DOCKETED						
Docket Number:	20-RENEW-01					
Project Title:	School Energy Efficiency Stimulus Program					
TN #:	236666					
Document Title:	EBTRON comments to the SRVEVR Guidelines					
Description:	N/A					
Filer:	System					
Organization:	EBTRON/Darryl DeAngelis					
Submitter Role:	Public					
Submission Date:	2/5/2021 1:55:22 PM					
Docketed Date:	2/5/2021

EBTRON comments to the SRVEVR Guidelines

Re: School Reopening Ventilation and Energy Efficiency Verification and Repair Program Guidelines

Figure 2

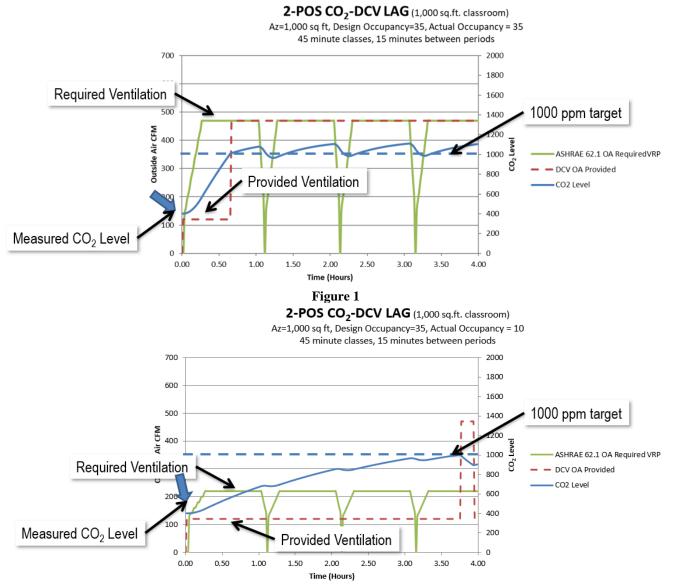
off the minimum rate for DCV per Table 120.1-A. The results may look like what is shown in Figure 1. I this example DCV is set to 1000 ppm. The result is the 1st period classroom is under-ventilated until steady state is met. Steady state cannot be achieved until a population has been established, and maintained, within the space. A pre-occupancy purge would clean out by products for the room, however would do nothing to dilute any potential virus generated when the room becomes occupied. If schools open with classrooms having lower than design occupancy, then the result may look more like Figure 2, and there will be under-ventilation for a longer periods.

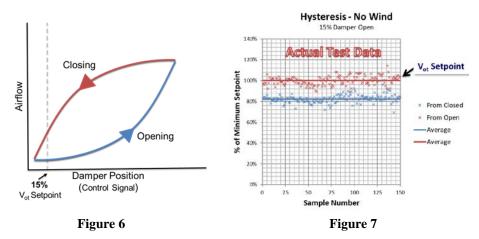
Many economizer systems on were manufactured in the past with not only leaky dampers, but excessive slop in the actuated drivetrain gear or linkage assembly. The result is an actuator may rotate, but the damper may not. This causes the inability to be reliant on actuator position to always position the damper in the same location. Therefore, the field measured outdoor air at one moment in time may not be reproducible the next time. You can have the best ATT or TAB, and they can't resolve this inherent problem with measurement and adjustment alone. ASHRAE Standard 111 puts it this way, "certification that airflow rates meet specification is the most difficult field measurement that a TAB engineer has to perform" The inability to hit the same position exists whether moving from closed position to minimum or from economizer mode to minimum. In economizer mode, and DCV, there is closed loop logic that will continue to adjust until the desired sensor value is achieved. In minimum ventilation mode however, the actuator is driven to a position without verification that this position has been achieved. Actuator feedback only provide actuator internal motor position and not damper positions. Damper curves are not linear and change from unit to unit based on conditions and damper authority <u>Belimo Damper Application Guide</u>.

In 2013 when the requirement for low leak economizer dampers and economizer cycle testing was incorporated, there was a reduction of mechanical slop, however the seals that give a damper low leakage rating, also generate increase hysteresis, the tendency to arrive at different positions for the same signal input when moving in different directions. Figures 6 Illustrates hysteresis, Figure 7 is actual data of a low leak damper, where 100% equals minimum position setpoint. It shows when going from closed to minimum position that the minimum position is never achieved and the mean is 82% of the target. Regardless of the damper curve that is already greater than 10% below minimum ventilation. This is without considering other impacts such as wind, increased filter pressure drop, and more. Position by itself is not an repeatable validation of airflow rate.
